GENERAL APPLICATION

Location Address: 1942 Taylor Street, Hollywood, FL 33020

Explanation of Request: Multi Family Dwelling

SUBJECT: Preliminary Site Plan review for an 18-unit residential development
Owner/Applicant: MEC INVESTMENTS INC
Address/Location: 1942 Taylor St
Net Size of Property: 10,759 sq. ft. (0.25 acres)
Land Use: Regional Activity Center (RAC)
Zoning: North Downtown High Intensity Mixed-Use District (ND-3)
Present Use of Land: Residential
Year Built: 1925 - 1954

CONTEXT RENDERINGS

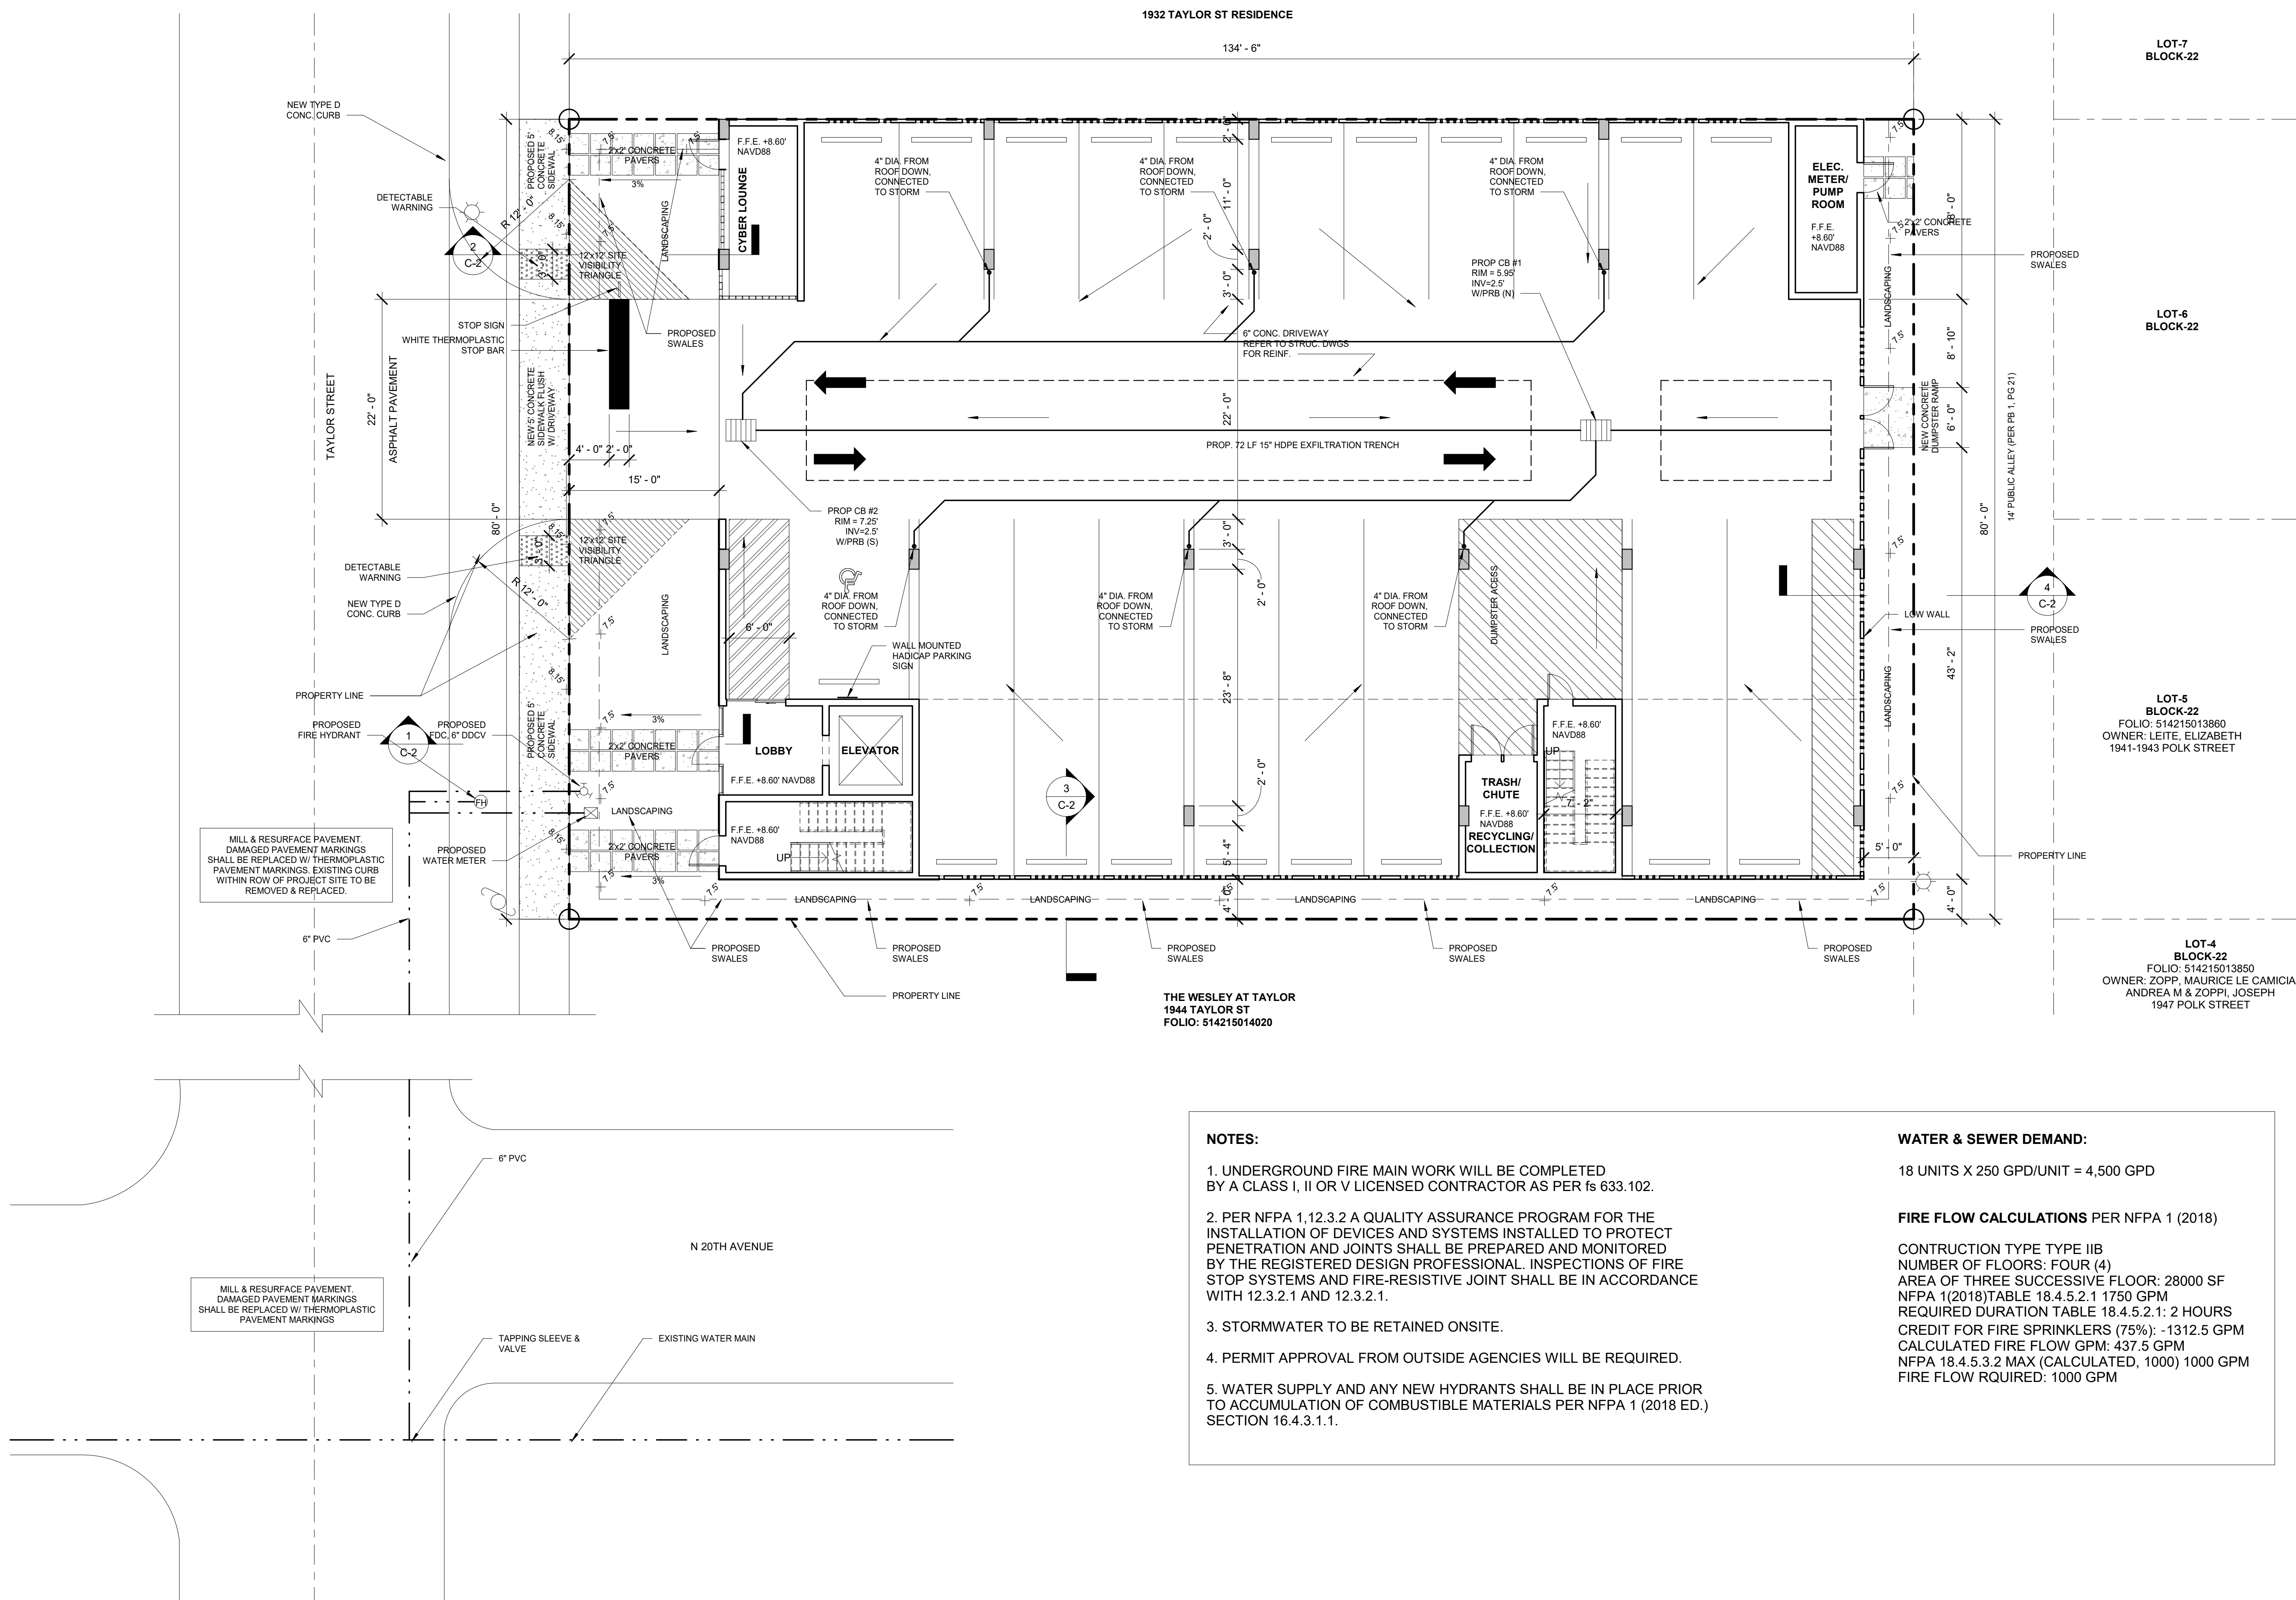
- 1. Provide a rendering of all the sides. **Refer to A000, A200a, A201a, A202a, A203a & A205.**
- 2. Provide a note: All changes to the design will require Planning review and may be subject to Board approval. **Refer to A100 notes, note added.**
- 3. Indicate and demonstrate access to the dumpster on site plan. Label dumpster pad/ramp that provides access. **Refer to A100, path lines added.**
- 4. Work with the Building Department to ensure that adequate ventilation is provided for the parking garage. **Refer to A100 notes, note added.**

3. The proposed architecture of the building appears to be flat with almost no articulation. The CRA would like to recommend adjusting the massing of the building and/or incorporating additional architectural elements to help improve the architecture of all four elevations. **Facades modified, refer to A000, A200a, A201a, A202a, A203a & A205.**

C-1

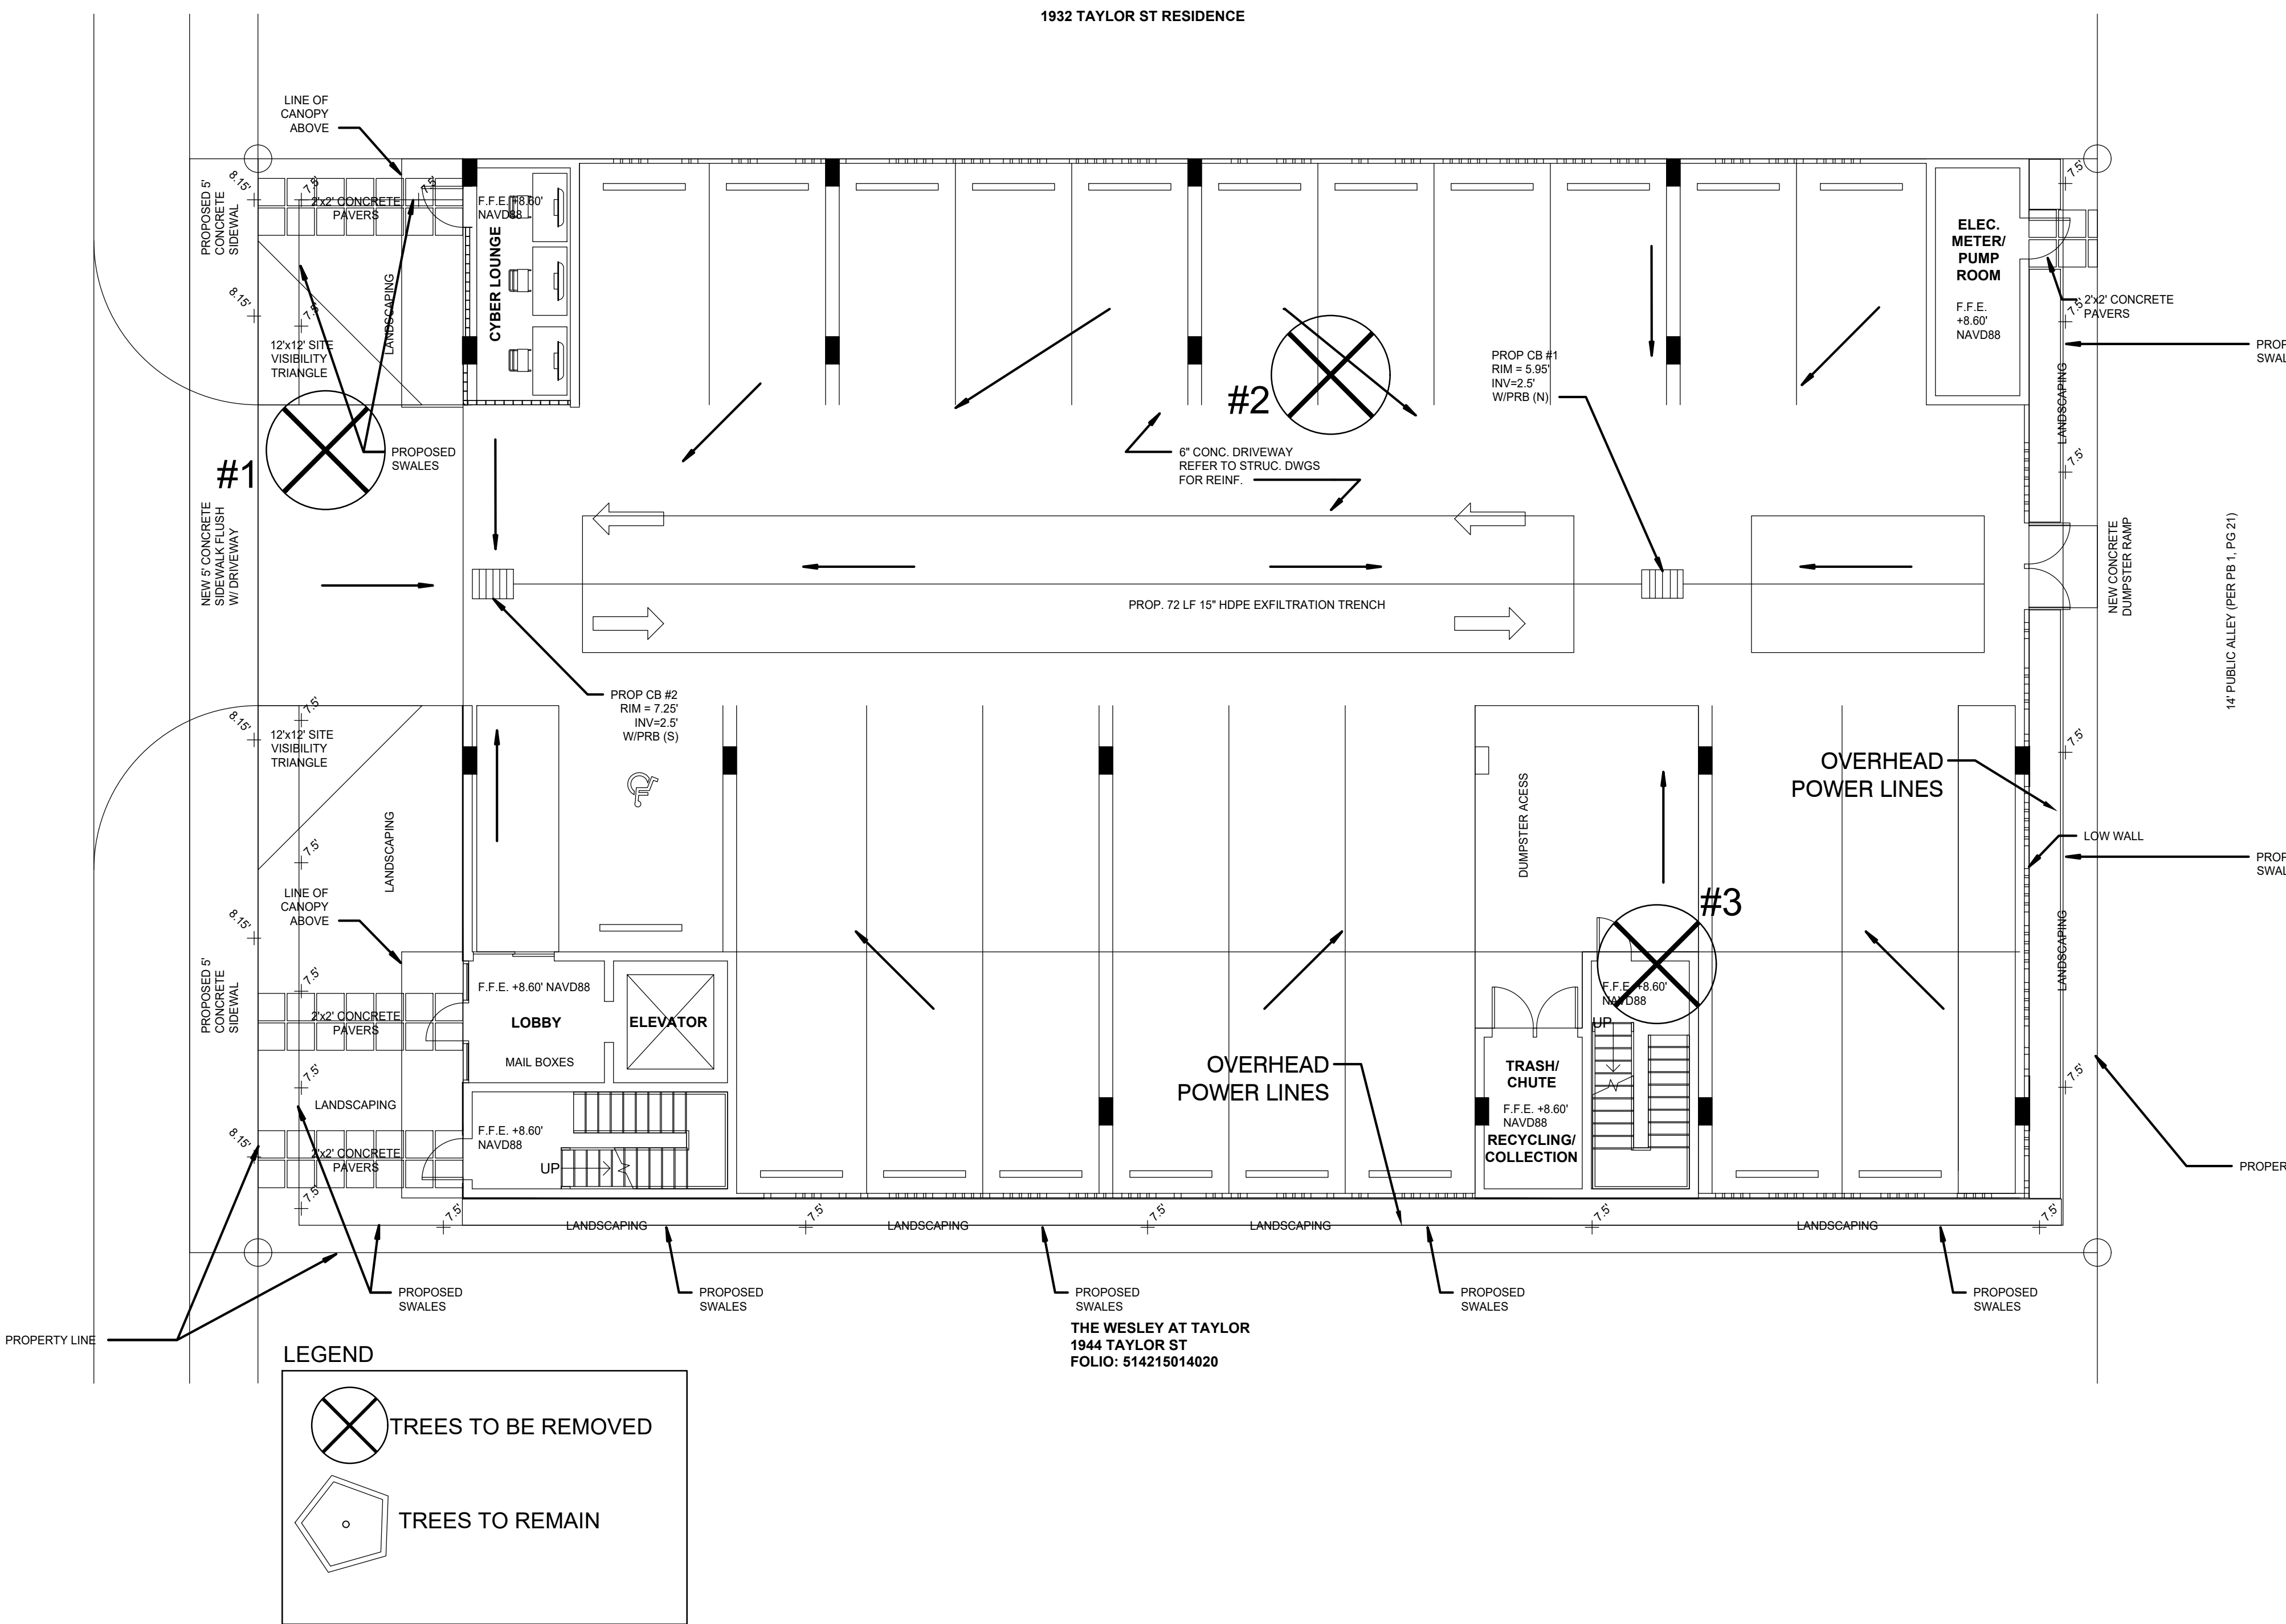
1. Submit civil engineering plans indicating existing and proposed Water, Fire, Sewer, and Drainage for initial review. **Refer to civil drawings, C-1.**

2. Show Water and Sewer demand calculations on proposed utilities plans. **Refer to civil drawings, C-1.**
3. Include the City's latest applicable standard Water and Sewer details. The details are available on the City's website via the following link: <http://www.hollywoodfl.org/1169/Standard-Details-and-Public-Notices> . **Refer to civil drawings, C-4 & C-5.**

5. Indicate FFE for all enclosed areas on the ground floor. **Refer to civil drawings, C-1.**
6. Provide perimeter cross sections across all property limits including transition areas meeting adjacent property grades. **Refer to civil drawings, C-2.**

9. Provide preliminary drainage calculations. **Refer to civil drawings, C-1.**
10. Submit Erosion Control Plan. **Refer to civil drawings, C-3.**
11. Permit approval from outside agencies will be required. **Refer to civil drawings, C-1 notes.**

3 - Water supply and any new hydrants shall be in place prior to accumulation of combustible materials per NFPA 1 (2018 Ed.) Section 16.4.3.1.1. --- Provide a note on the plans. **Refer to civil drawings, C-1 notes.**

Ensure on the plans that there is a fire hydrant within 100 feet of fire department connections as required by NFPA 14 (2016 Ed.) Section 6.4.5.4 --- "Fire department connections shall be located not more than 100 ft (30.5 m) from the nearest fire hydrant connected to an approved water supply." **Refer to civil drawings, C-1.**

5 - Provide a note on civil drawing all underground fire main work must be completed by fire protection contractor holding a Class I, II, or V license per FS 633.102. **Refer to civil drawings, C-1 notes.**
